**Development Application No. DA2024/1303
Issues response/ Supplementary Statement of Environmental Effects
Forestville RSL Club redevelopment including new Club building and
seniors housing
22 Melwood Avenue, Forestville**

Reference is made to Council's request for further information (RFI) of 21st January 2025, the subsequent Sydney North Planning Panel (SNPP) Briefing Note which had regard to without prejudice plans submitted in response to the RFI for Council comment/ feedback and the Record of Briefing from the SNPP meeting of 26th March 2025.

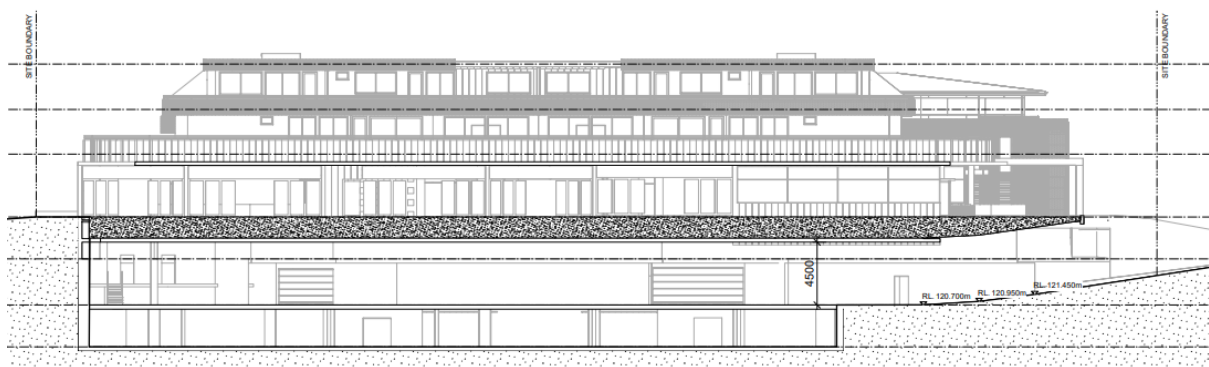
Deep Soil

Response: The proposal provides for a total deep soil landscaped area having a minimum dimension of 3 metres of 1740m² representing 19% of the site area in strict accordance with the minimum 15% SEPP housing standard. The additional deep soil landscape opportunity is located around the perimeter of the site where additional landscape treatments are proposed which will soften and screen the development as viewed in the round.
